<p>نگهداشت و افزایش تولید میدان نفتی بینک سطح الارض</p> <p>احداث ردیف تراکم گاز در ایستگاه جمع آوری بینک</p>																									
<p>شماره پیمان: ۰۵۳ - ۰۷۳ - ۹۱۸۴</p>

<table><tr> <th colspan="8">HAZOP REPORT FOR COMPRESSOR STATION</th> </tr><tr> <td>D00</td> <td>0004</td> <td>RT</td> <td>GE</td> <td>120</td> <td>PEDCO</td> <td>GCS</td> <td>BK</td> </tr></table>

The purpose of this document is to provide the results of “HAZOP Study” for **Binak Oilfield Development – Surface Facilities; New Gas Compressor Station**.

V-2101C
1ST STAGE GAS COMPRESSION SUCTION
DRUM TRAIN #C
DIMENSIONS (ID X TL-TL) : 900 X 2840 mm
DESIGN TEMP. : 85 °C
DESIGN PRESS. : FV/9 barg

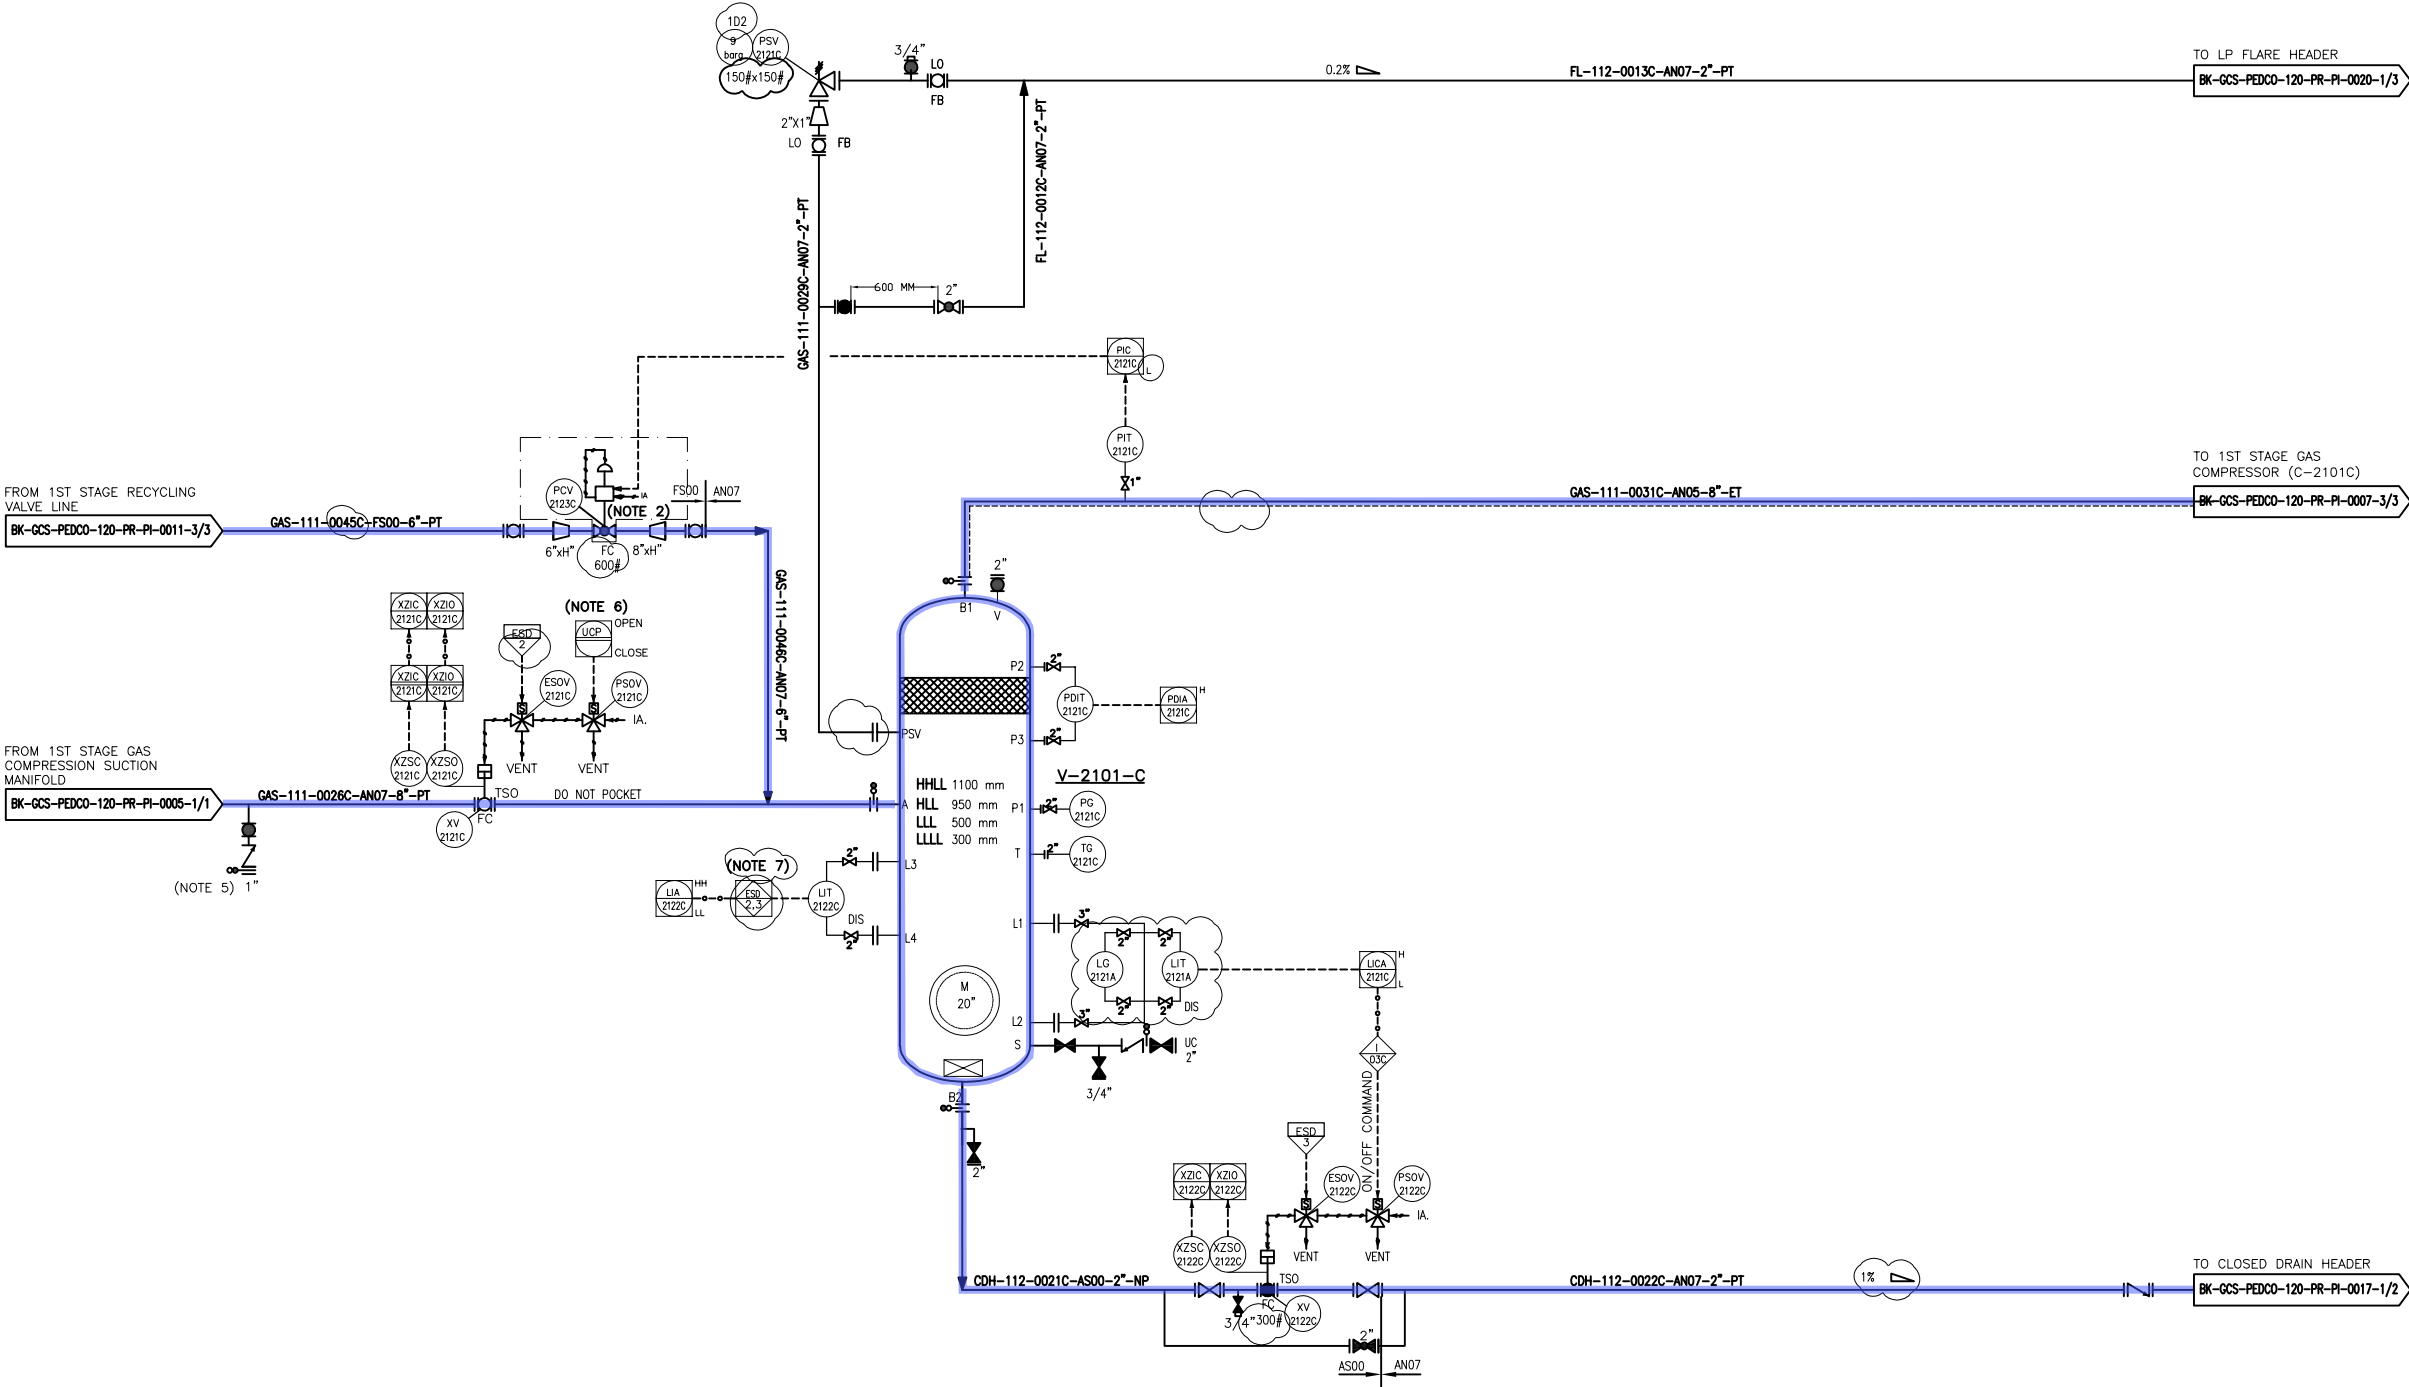
40. Consider maintenance lock for fan of air coolers in data sheet.	Consequences: 5.10.1.1	Contractor	Closed
41. Consider drain connection on low point of line between V-2101A and compressor.	Consequences: 5.11.1.1	Contractor	Closed

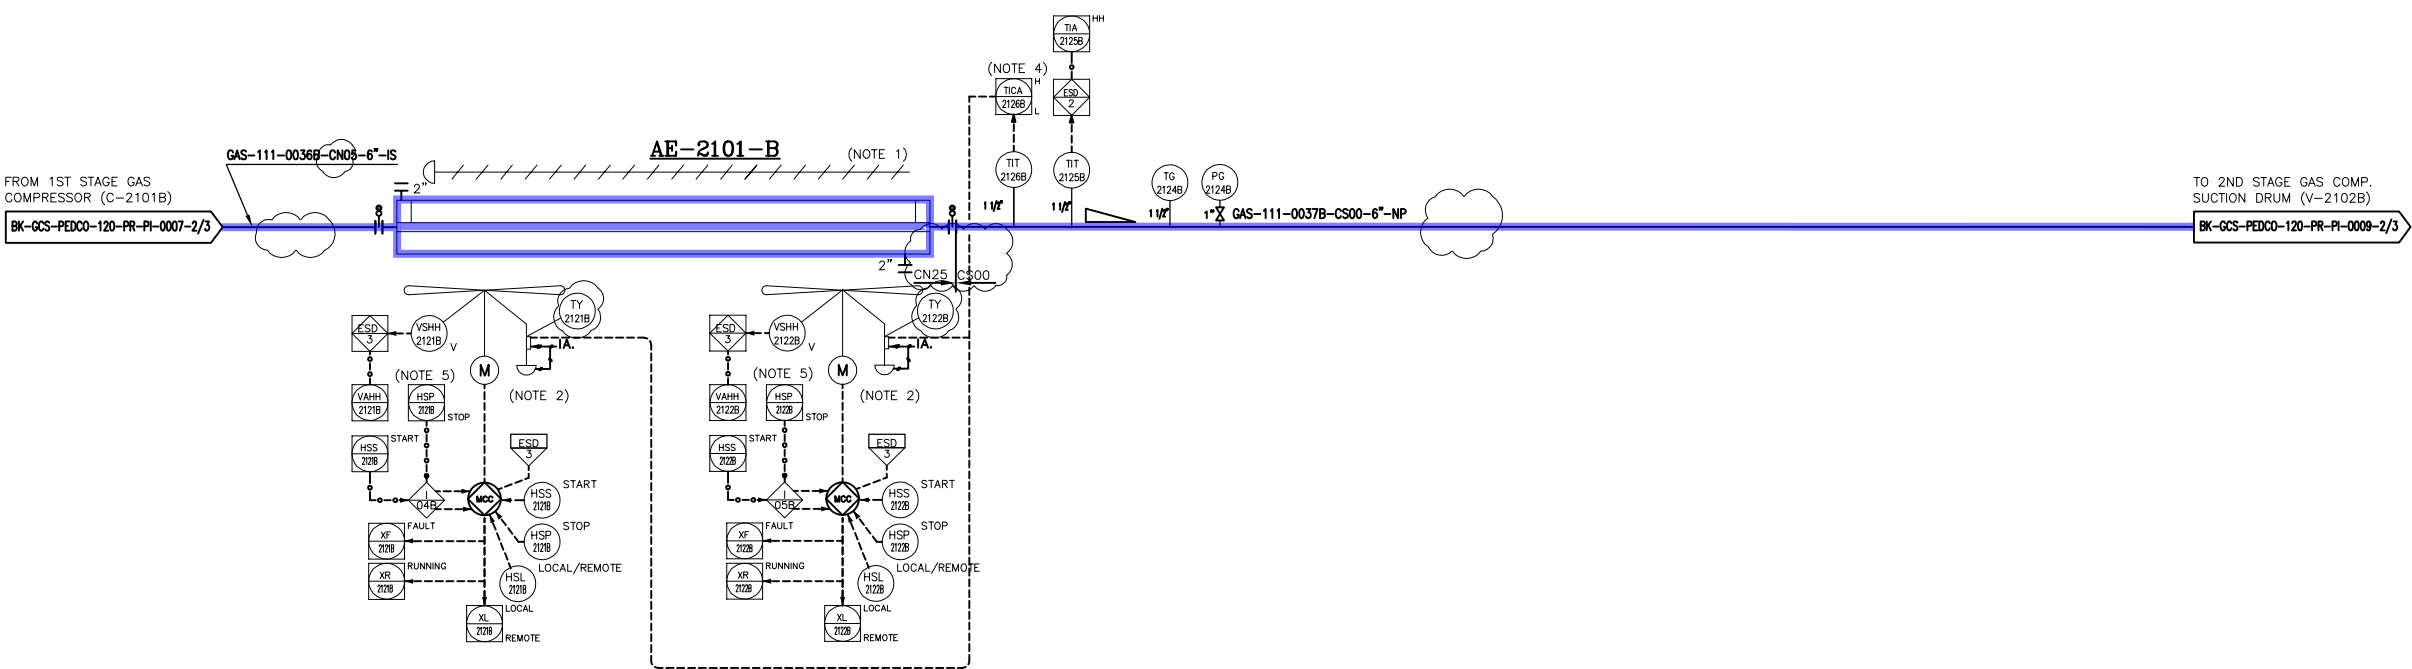
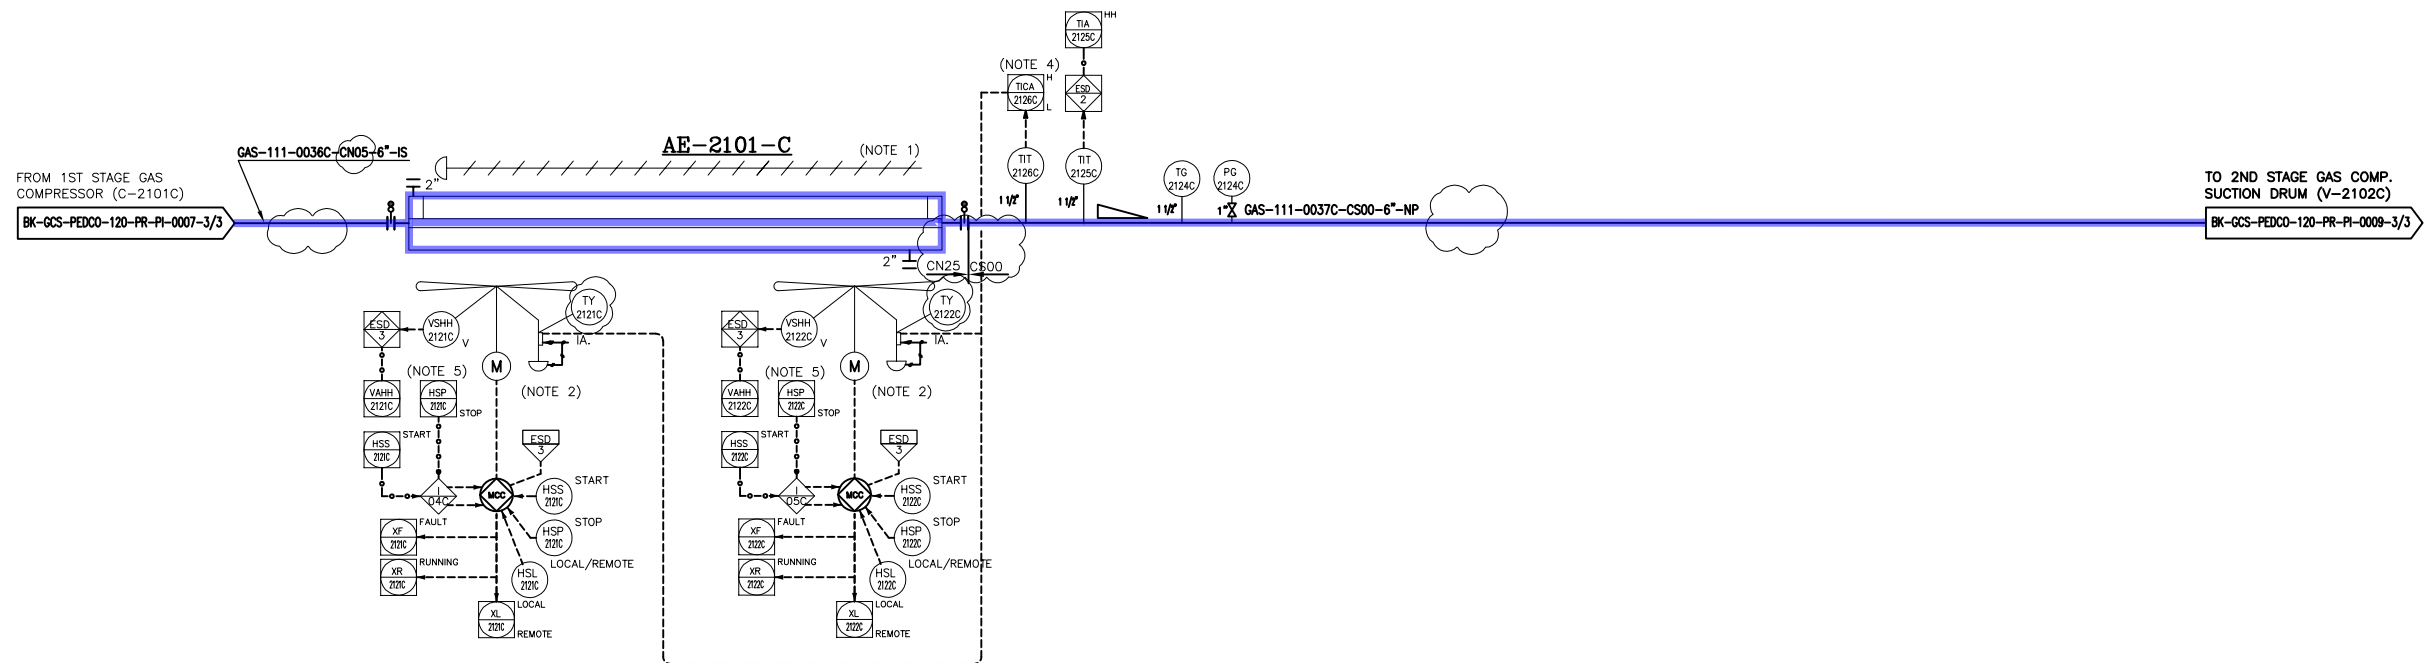
38. Correct P&ID of air coolers of compressors according to data sheet.	Consequences: 5.4.3.1, 6.4.3.1	Contractor	Closed
39. Consider block valves for N2 supply lines to compressor packages.	Consequences: 5.10.1.1	Contractor	Closed

V-2103
GAS COMPRESSION DISCHARGE DRUM

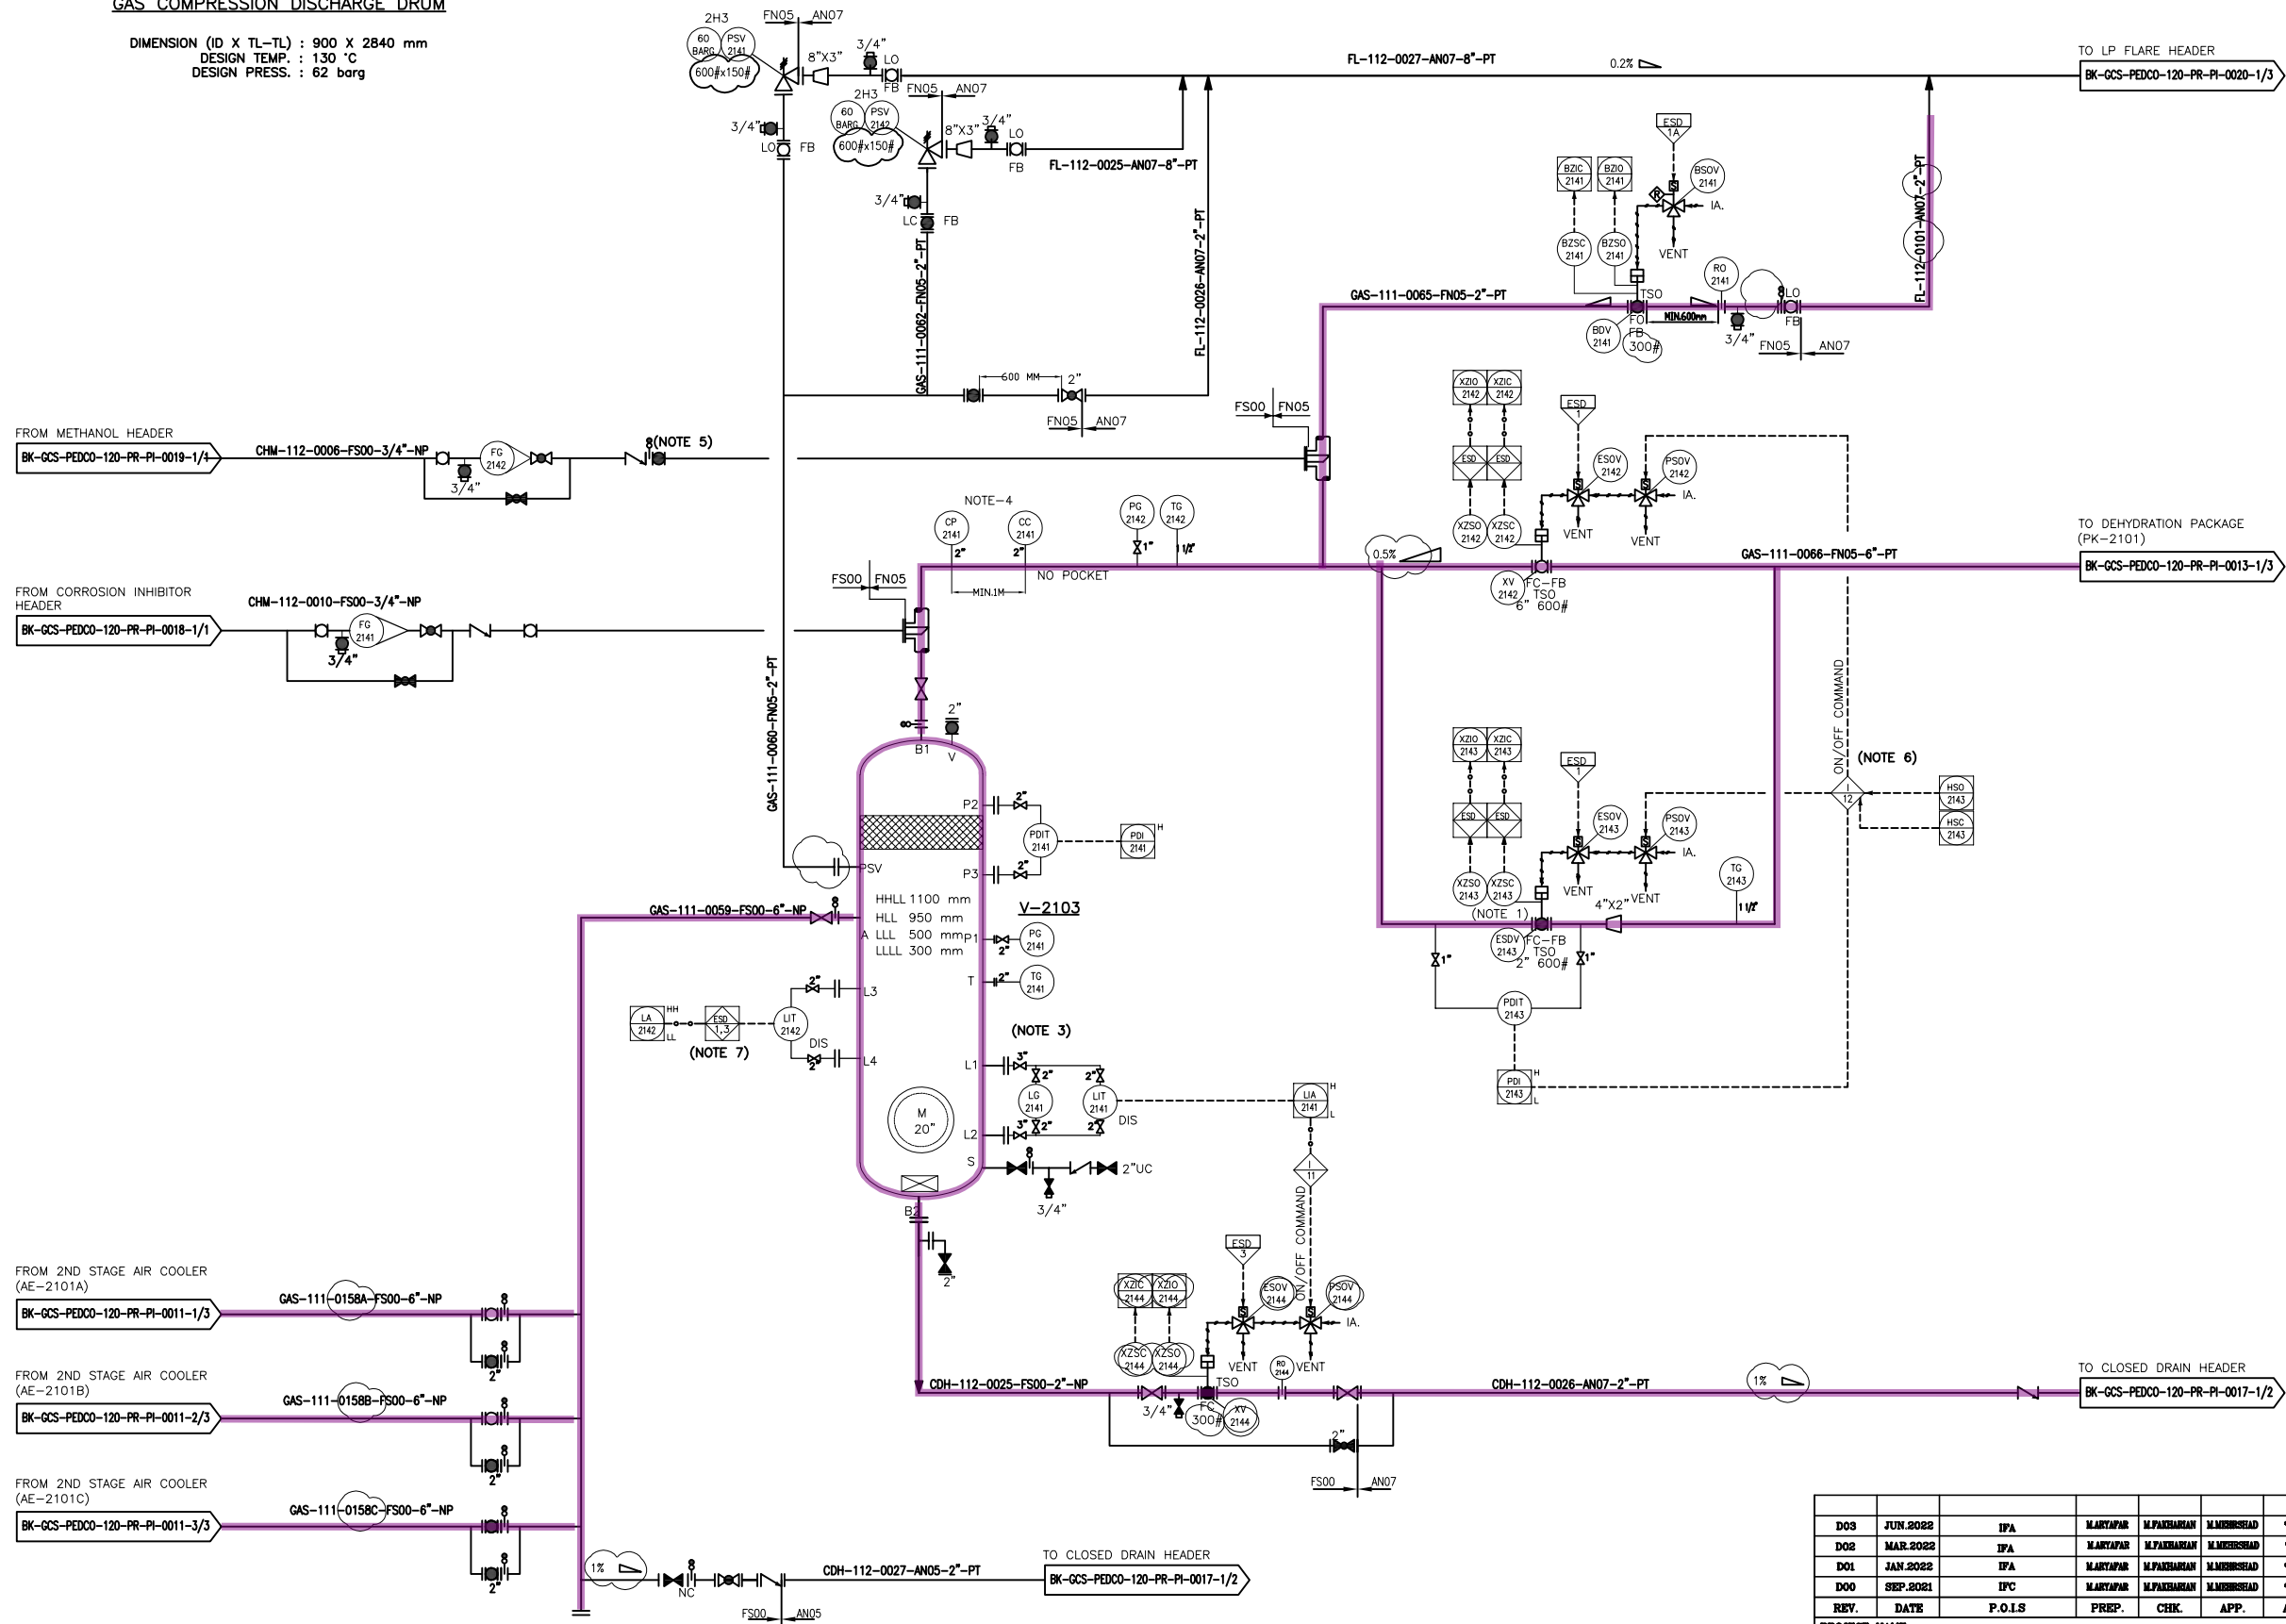
47. Remove sample connection on suction and discharge of compressor 2nd stage.	Consequences: 6.12.1.1	Contractor	Closed
48. Correct on P&ID that outlet pipe of BDV 2141 is connected directly to flare header separated from tail pipe of PSVs	Consequences: 7.5.1.1	Contractor	Closed

49. Full vacuum should be considered for design pressure of V-2103.	Consequences: 7.5.2.1	Contractor	Closed
50. Show on P&ID stand pipe for LG-2141 and LIT-2141.	Consequences: 7.6.1.1	Contractor	Closed

54. Show on P&ID line number and inlet reducer of XV-2143.	Consequences: 7.10.1.1	Contractor	Closed
55. Remove TG-2143.	Consequences: 7.10.1.1	Contractor	Closed
